DEVELOPMENT NO.:	25013655
APPLICANT:	Abela Design & Drafting Turnbull Built
ADDRESS:	3 SMITH AVENUE, HOVE
NATURE OF DEVELOPMENT:	Two storey detached dwelling, outbuilding (pool room) and swimming pool
ZONING INFORMATION:	Zones: <ul style="list-style-type: none"> • General Neighbourhood Overlays: <ul style="list-style-type: none"> • Airport Building Heights (Regulated) • Affordable Housing • Building Near Airfields • Prescribed Wells Area • Regulated and Significant Tree • Stormwater Management • Urban Tree Canopy
LODGEMENT DATE:	21 May 2025
RELEVANT AUTHORITY:	Assessment Panel at City of Holdfast Bay
PLANNING & DESIGN CODE VERSION:	P&D Code (in effect) Version 2025.9 15/05/2025
CATEGORY OF DEVELOPMENT:	Code Assessed - Performance Assessed
NOTIFICATION:	Yes
RECOMMENDING OFFICER:	Dean Spasic Development Officer - Planning,

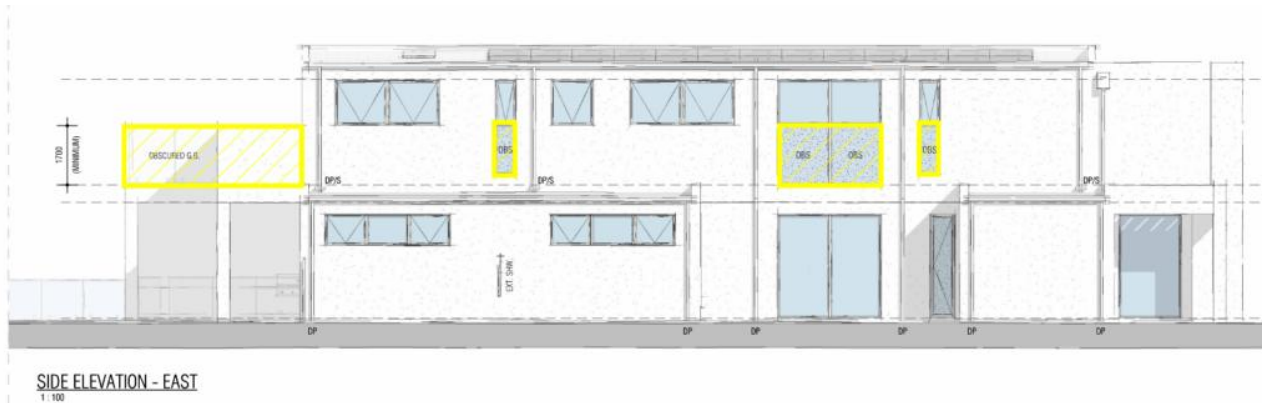
The Zone accommodates 2 building levels and a maximum external wall height of 7 metres above the footing. The proposed dwelling comprises 2 building levels and an external wall height of 7.1 metres, which exceeds the maximum Designated Performance Feature 4.1 guide by 100mm. This height exceedance is negligible and acceptable, with the flat roof form having an overall building height well below the suggested maximum of 9m.

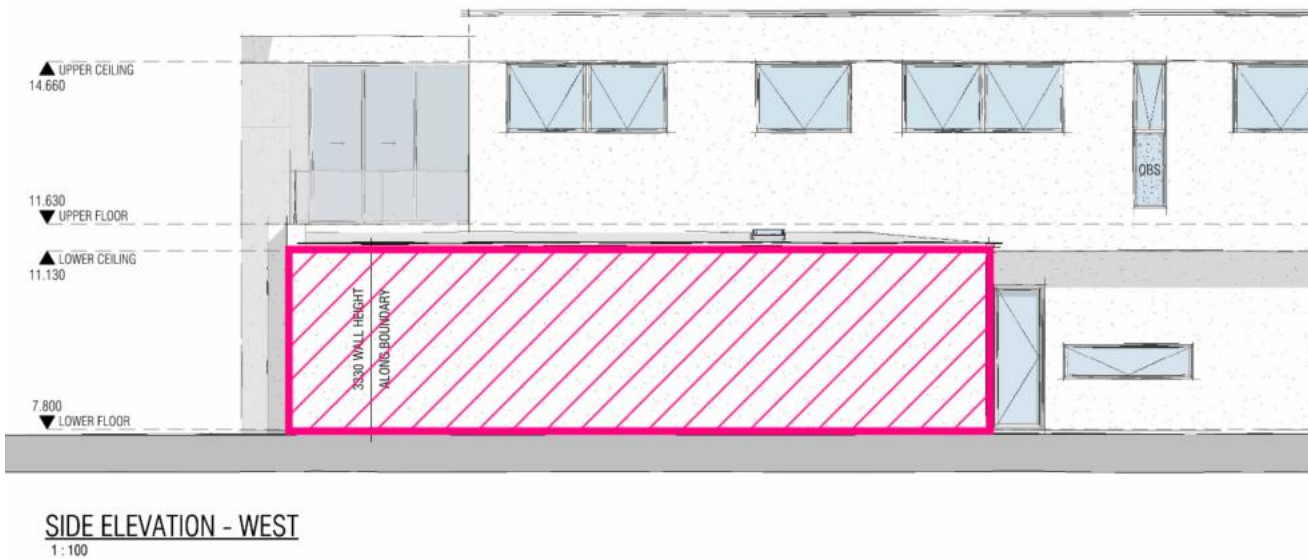
The building has a 13 metre long garage wall located on the western side boundary with a wall height of 3.3 metres above the top of the footing. Zone DPF 7.1 and the public notification table suggest a maximum boundary wall length of 11.5 metres and wall height of 3 metres. However, Performance Outcome 7.1 is satisfied in that the boundary walls are limited in height and length to manage visual and overshadowing impacts on adjoining properties. The garage boundary wall in this case is on the low side, adjacent to the western neighbour's substantial double width carport which is enclosed with timber slats so that visual and overshadowing impacts are limited and acceptable.

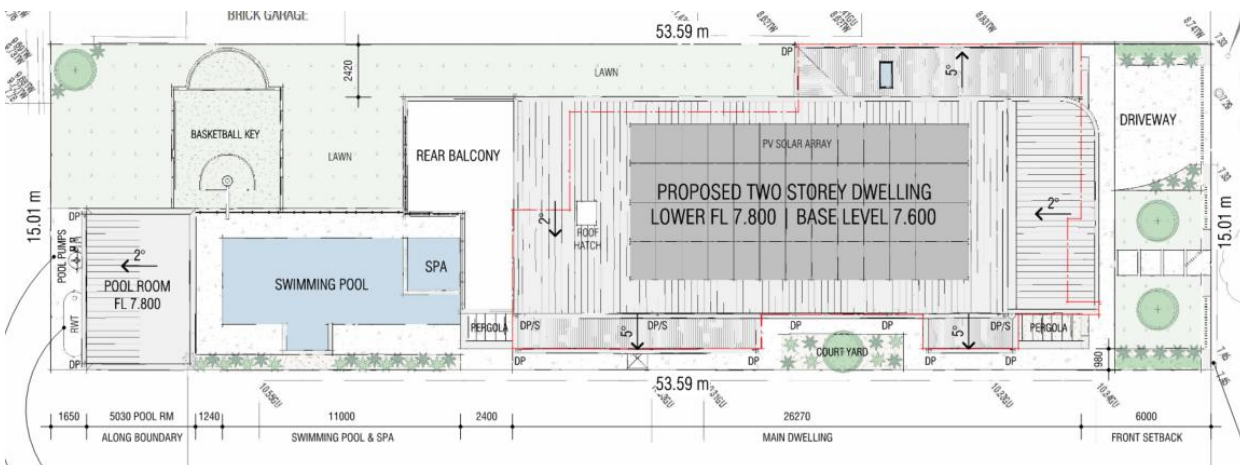
The dwelling rear setback comfortably satisfies the 6m sought by Zone DPF 9.1.

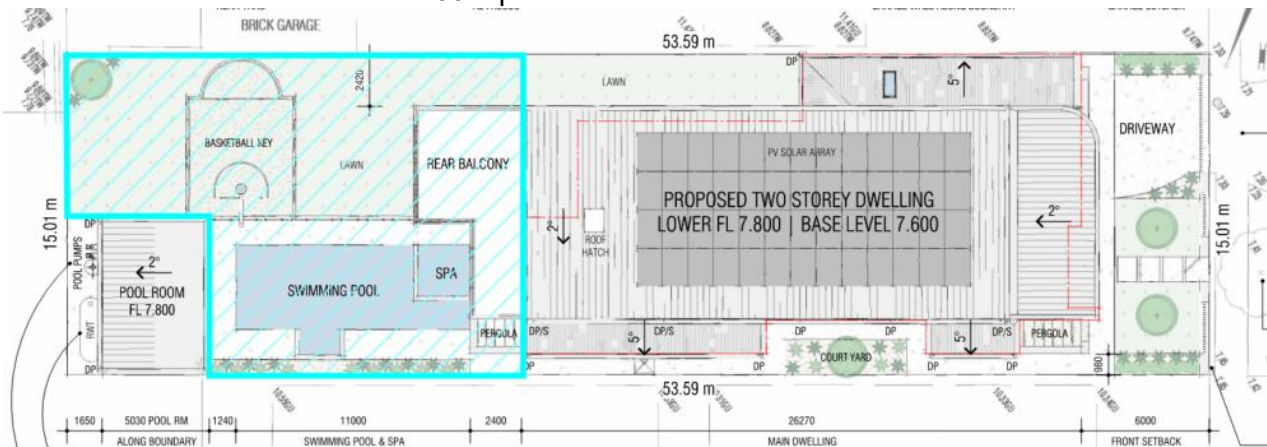
The proposed development provides for a private open space area of 270 square metres, which far exceeds the desired minimum of 60 square metres.

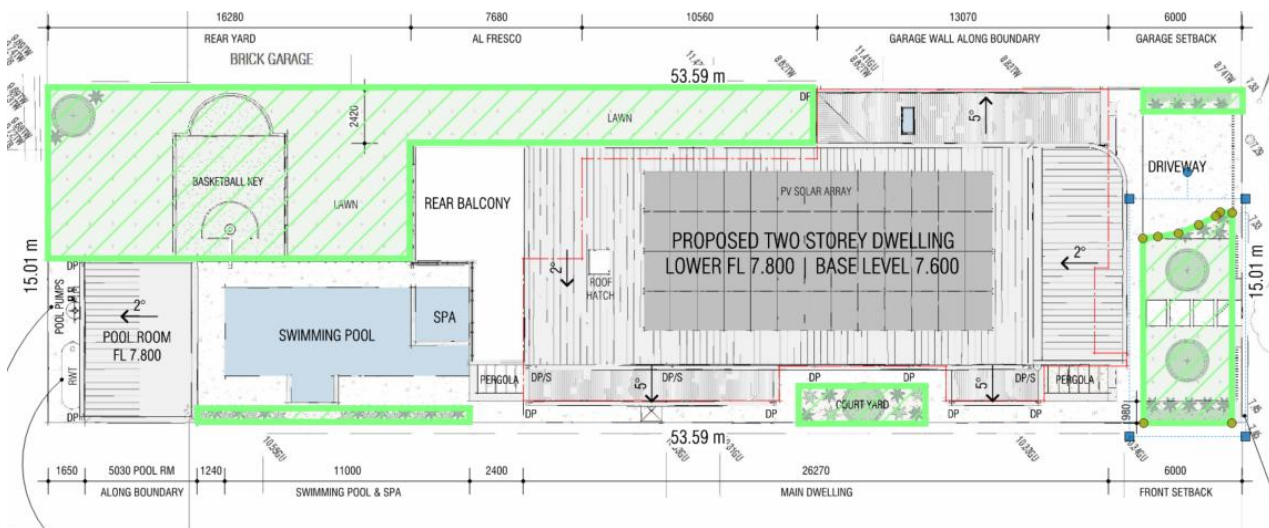
Soft landscaping amounts to 27 percent of the site area, which exceeds the minimum of 25 percent suggested by Design in Urban Areas DPF 22.1. The landscaping proposed minimises heat absorption and reflection, contributes to shade and shelter, provides stormwater infiltration and biodiversity, and enhances the appearance of land and streetscapes.

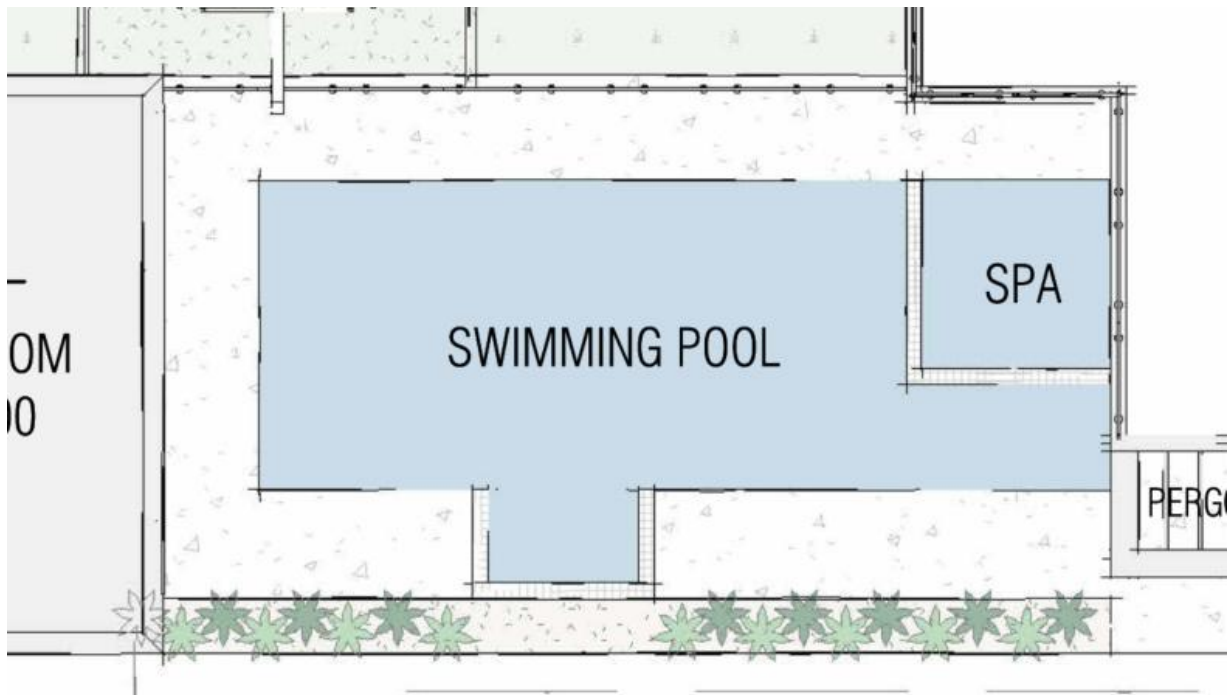
The proposed swimming pool is also located in the rear yard, away from allotment boundaries and does not present any adverse planning impacts. A condition of planning consent is included to manage pool equipment noise.

8. The pool filter pump must be enclosed in such a way that noise levels do not exceed 52 dB(A) between 7am and 10pm on the same day, and 45dB(A) between 10pm and 7am the next day measured at adjoining property boundaries.
